Docket No. STN 52-001

Subject: Submittal Supporting Accelerated ABWR Review Schedule - **Tier 1/ITAAC:
Submittal of Revised Material from the January 11 through January 21, 1993
and March 8 through March 12, 1993 GE/NRC Meetings**

Enclosed are revised versions of the ABWR Tier 1 ITAAC material that was reviewed during the January 11 through January 21 and March 8 through March 12, 1993, GE/NRC meetings. The attached Tier 1 entries reflect a) changes to the design descriptions and ITAAC tables as a result of the punch list items identified during the meetings; b) restructuring of the system entries so as to give (to the extent practical) consistent system-to-system treatment of technical issues; c) changes that maximize use of standardized entries for issues that appear repetitively in multiple systems. Also enclosed are written dispositions of the punch list items from the January and March meetings.

Figure 2.1.2d NBS Safety/Relief Valve Pneumatic Lines

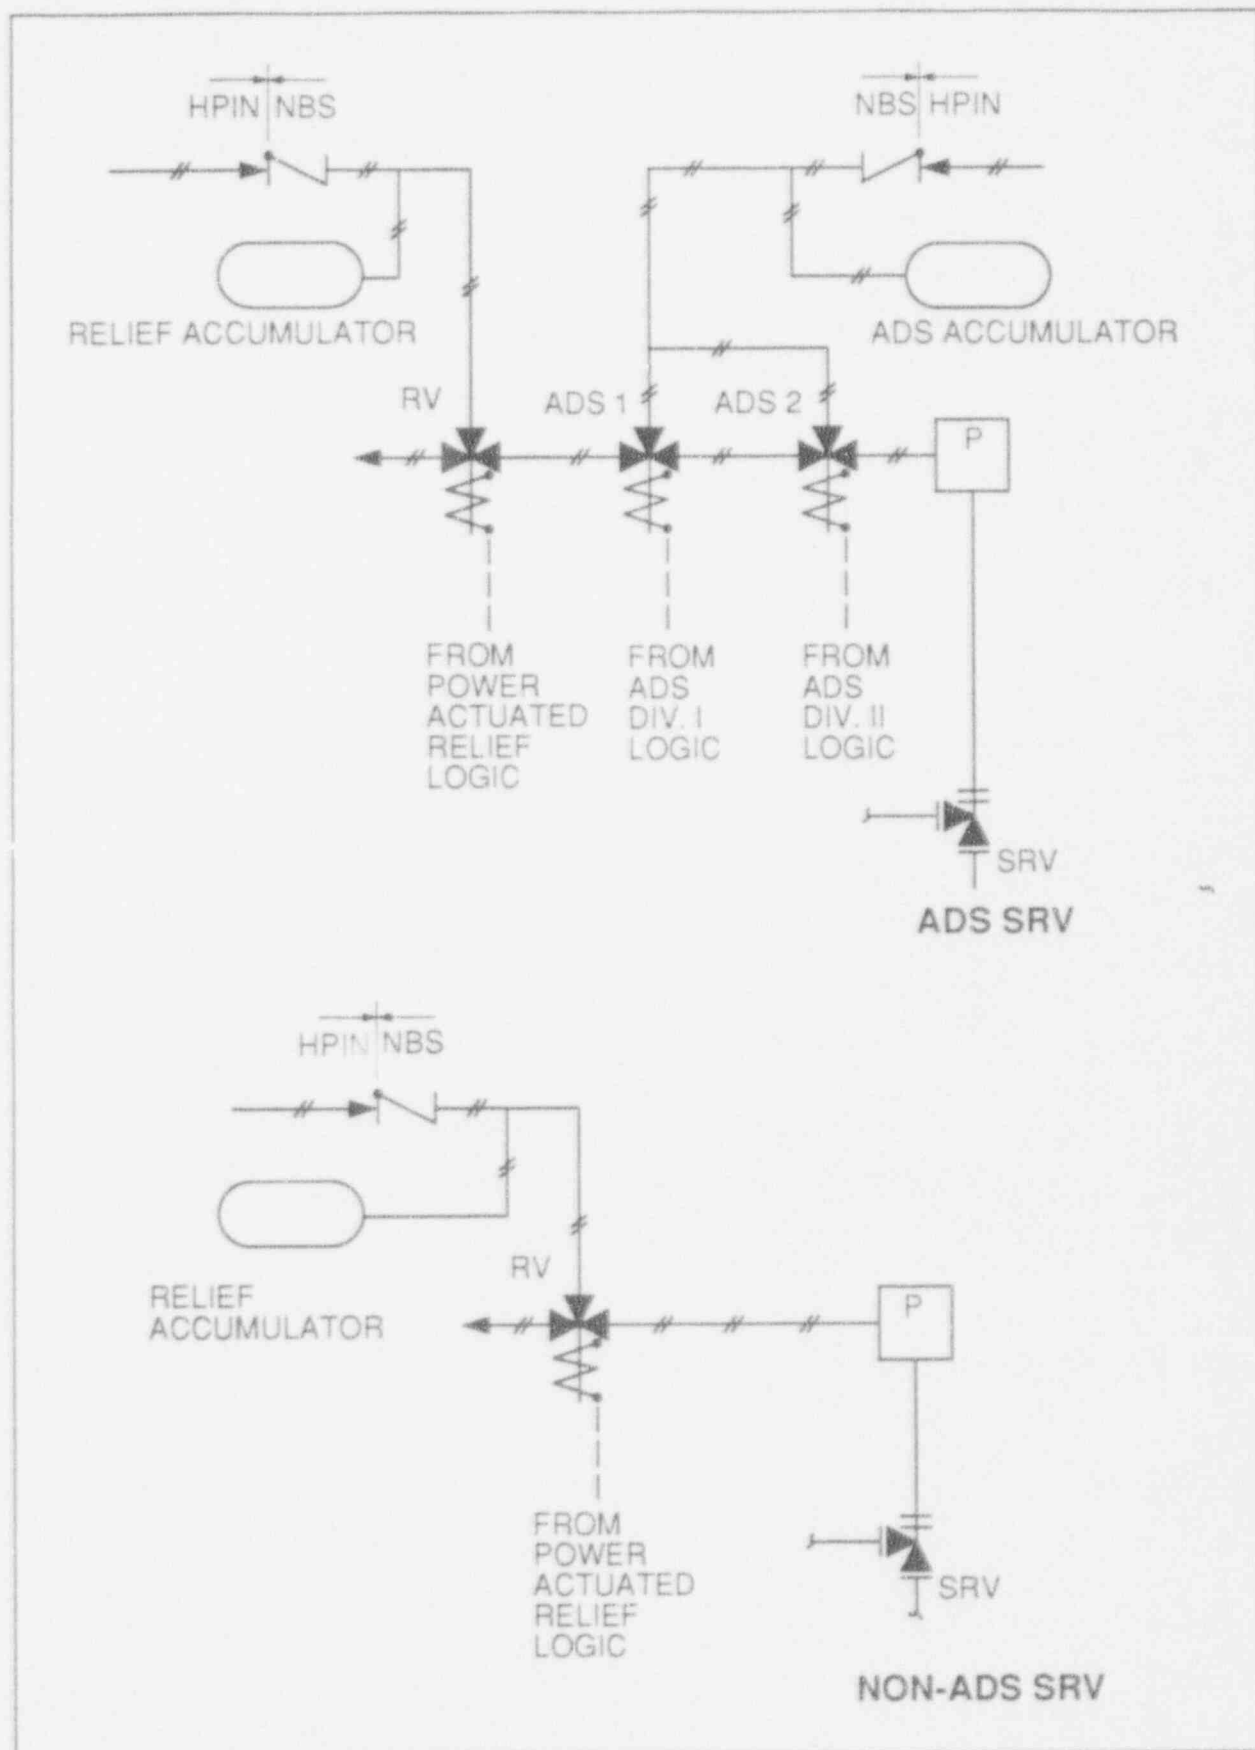
PUNCH LIST ITEM: A. Need to reference Figure 2.1.2D and include it.

GE DISPOSITION: This figure is now included in the revised Section 2.1.2 and is referenced from the text.

Figure 2.1.2e NBS Drywell Pressure and Reactor Vessel Instrumentation

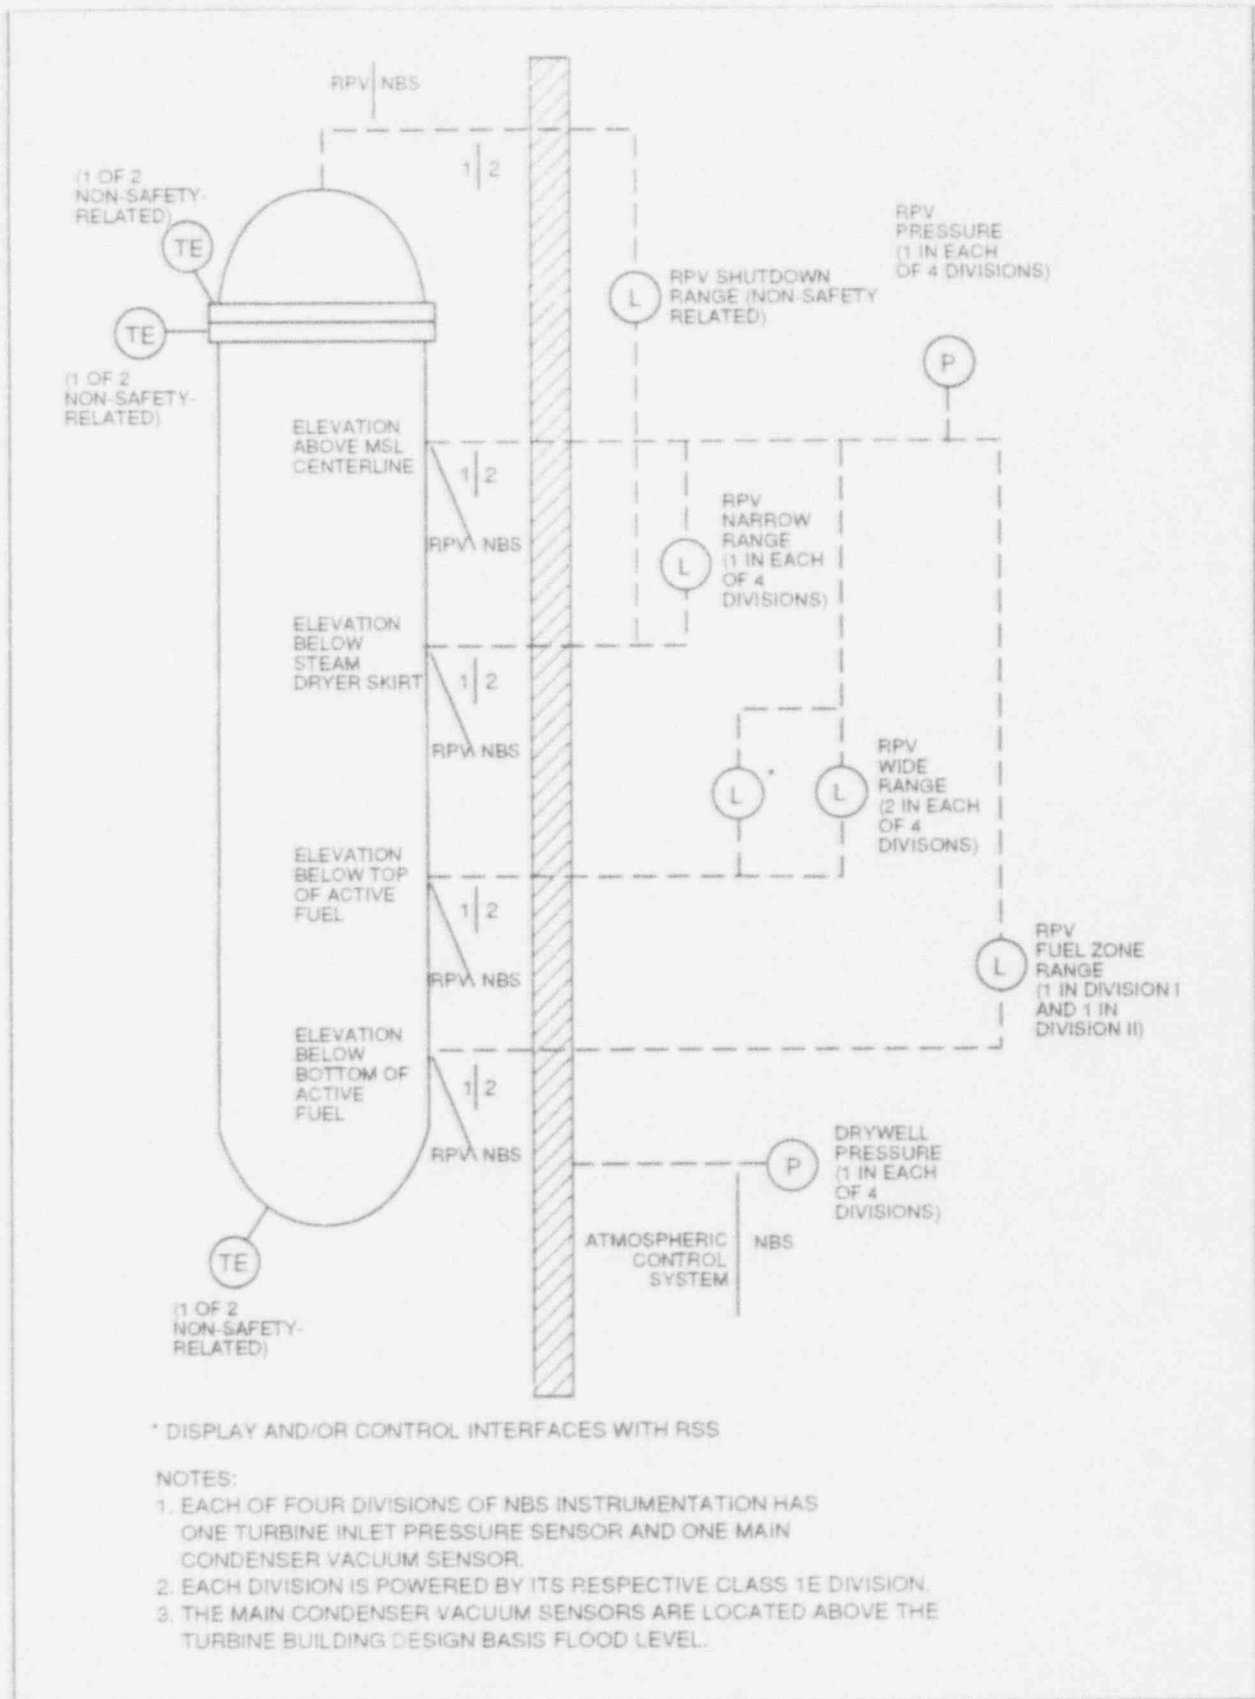
PUNCH LIST ITEM: 1. Add NNS level measurements to NBS figures/design description.

GE DISPOSITION: The non-safety-related instruments used to provide input to the feedwater control system have been added to the Nuclear Boiler System's instrumentation figure.
